eceined by Och: 10/23/2024 1:36:18	State of New Me	exico	Form C-103 ¹
Office <u>District I</u> – (575) 393-6161 1625 N. French Dr., Hobbs, NM 88240	Energy, Minerals and Natu	ral Resources WEI	Revised July 18, 2013 LL API NO.
<u>District II</u> – (575) 748-1283	OIL CONSERVATION	DIVISION	30-015-42356
811 S. First St., Artesia, NM 88210 District III – (505) 334-6178	1220 South St. Fran	5 1	ndicate Type of Lease
1000 Rio Brazos Rd., Aztec, NM 87410	Santa Fe, NM 8'		STATE X FEE tate Oil & Gas Lease No.
<u>District IV</u> – (505) 476-3460 1220 S. St. Francis Dr., Santa Fe, NM 87505	Santa 1 C, 14141 07303		tate On & Gas Lease No.
SUNDRY NOTICES AND REPORTS ON WELLS (DO NOT USE THIS FORM FOR PROPOSALS TO DRILL OR TO DEEPEN OR PLUG BACK TO A		LIC DACK TO A	ease Name or Unit Agreement Name
DIFFERENT RESERVOIR. USE "APPLICATION FOR PERMIT" (FORM C-101) FOR SUCH PROPOSALS.)		OR SUCH	Cottonwood 2 State SWD

Re: Workover NOI

Cottonwood 2 St SWD 1

30-015-42356

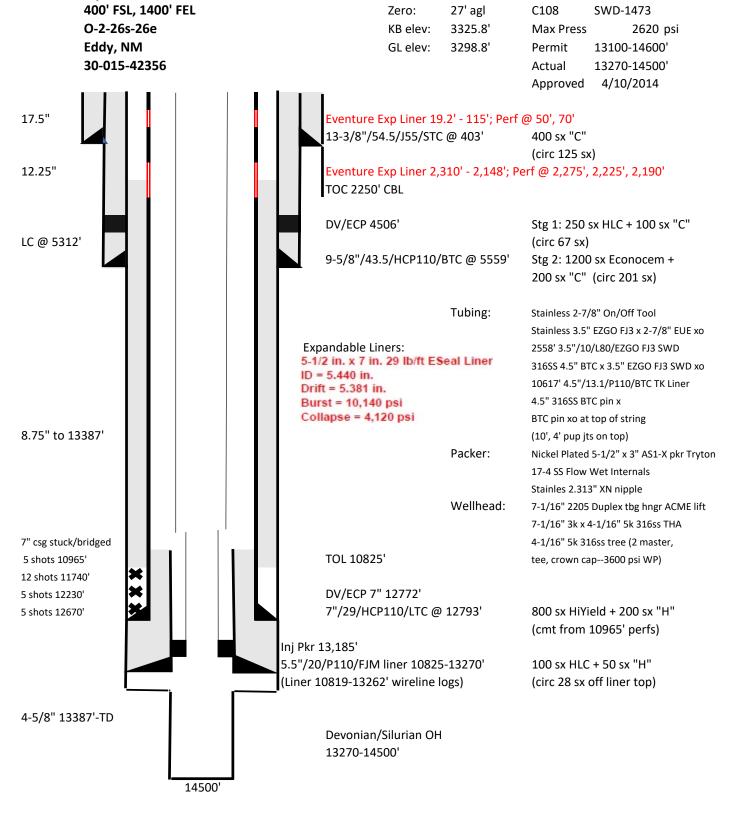
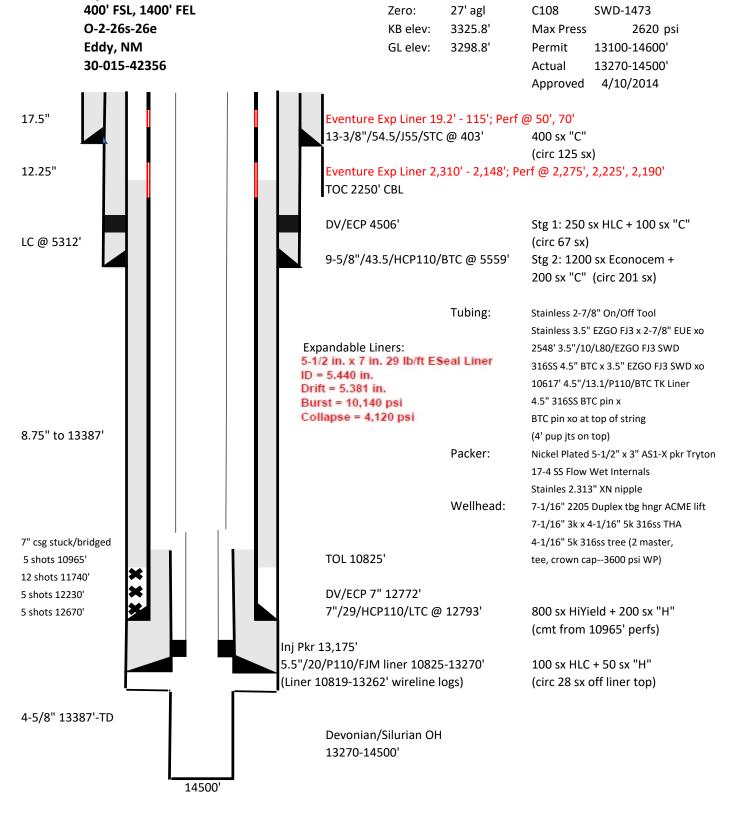
Solaris would like to give notice of intent for a remedial workover on the above captioned well to repair a suspected packer leak. The plan is to rig up a pulling unit with hydraulic BOPs and re-set the existing retrievable packer ten feet higher in the wellbore to see if a good seal can be obtained. MIT tests are good, but the tubing annulus builds pressure while the well is on injection.

If re-setting the packer if unsuccessful, the tubing string and packer will be pulled out of the hole and a new packer installed in place of the old one.

The same tubing string will be ran, identical to the previously installed string with 4-1/2", 11.6#, P-110, BTC, GRE from surface to 10,617' by 3-1/2", 9.30#, HCP-110, EZGO FJ3-SWD, IPC from 10,617' to 13,175' along with a new retrievable packer with proposed COE @ 13,175'. A new MIT will be called out and performed after the workover to ensure wellbore integrity.

Created By	Condition	Condition Date
mgebremichae	If the workover requires a change of tubing and packer, the replacement tubing must match the size specified in the respective SWD order, and the packer should not be set more than 100 feet above the top of the injection interval.	10/29/2024
